**RE: Pizza Hut – Coors Blvd & Avalon Rd
Grading and Drainage Plan
Engineer's Stamp Date: 04/14/18
Hydrology File: K10D020D**

Based upon the information provided in your submittal received 04/12/2018, the Grading and Drainage Plan **is not** approved for Building Permit. The following comments need to be addressed for approval of the above referenced project:

DRAINAGE REPORT

Pizza Hut Coors Blvd & Avalon Rd

Exhibit C – FIRM Map

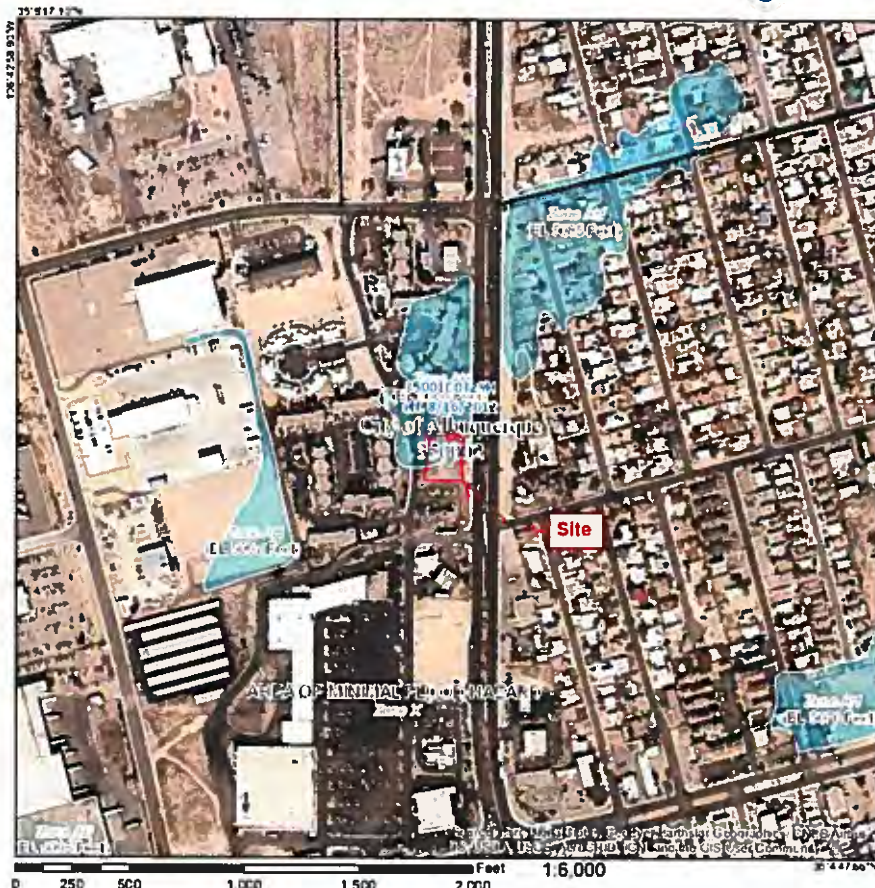
1. According to the latest Firm Map as you have indicated, this site is partially in Flood Zone AH. Please provide a written approval from FEMA prior to Hydrology approval.
2. Please provide Floodplain Permit prior to Hydrology approval.
3. Please fix the site location on the Vicinity Map. The existing Verlero gas station is highlighted.
4. Please show the two existing trees (see photo) and place a note that they will have to be removed.
